# GOVERNMENT OF THE DISTRICT OF COLUMBIA 10 DM 12: 25 OFFICE OF PLANNING

# **MEMORANDUM**

SUBJECT: BZA Application 17600 - Request filed by Pillsbury Winthrop Shaw Pittman LLP

for an area variance for the construction of a mixed-use building at 300 -320 Riggs

Proposed Site Plan

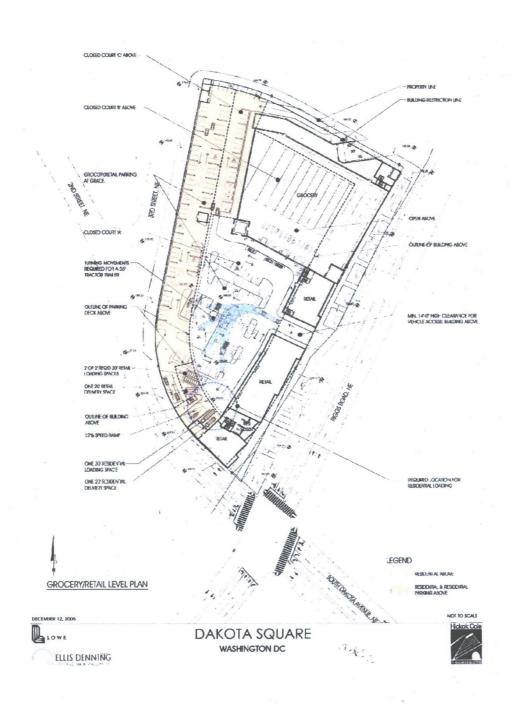
Section 2201.1 sets forth the minimum loading requirements. Apartment buildings with 50 or more units are required one loading berth a minimum of 55 feet deep in all zone districts. The application proposes to provide this loading berth at a depth of 30 feet, less than the minimum requirement. The application conforms to all other loading requirements as required, including for the retail component.

The subject property is unique. Although it occupies the entire square, topographical constraints restrict vehicular access to the property. The lot contains steep slopes downward from both 3<sup>rd</sup> Street and Chillum Place, leveling out as it approaches Riggs Road. Therefore, vehicular access is limited to Riggs Road, and easternmost 3<sup>rd</sup> Street and Chillum Place frontages. The shape of the property is also unique.

Although the property occupies the entire square, it is not square. Third Street curves around from the west to the south, as the topography slopes steeply downward from the north to the south, making it difficult for the larger trucks to navigate into loading bays from the street. As a result the site is designed to allow for 30-foot trucks to maneuver on-site, where the topography will be level. There is sufficient space within the commercial parking lot occupying the courtyard within the center of the building to allow 55-foot trucks to maneuver around as necessary. However, this would require the elimination of a substantial amount of the off-street parking and would not be a good use of the space. Therefore, the Office of Planning has concluded that the subject property is unique.

Not granting the requested variance will result in a peculiar and exceptional practical difficulty to the owner. It will result in the applicant having to set aside a substantial amount area within the building for the maneuvering of trucks only, an inefficient use of the space, or have truck maneuvering within the public streets, as there are no alleys.

The site plan minimizes the impacts to traffic and streetscape character by locating the loading bays internal to the site. However, a 55-foot loading berth cannot be provided without eliminating a significant amount of on-site retail parking. Therefore, the proposal is considered to be of benefit to the neighborhood. One and two-bedroom units, as proposed for the subject building, do not typically 55-foot long trucks, and adequate loading for the proposed retail uses is provided. As such, the granting of this variance will not impair the intent and integrity of the zone plan as it will allow for a more efficient design for the building. In addition, the requirement for a 55-foot loading berth is not based on the size of the units within the building, but rather the number of units within the building. By limiting the size of the proposed units to no more than two bedrooms, the need for the larger loading berth will not be engaged.
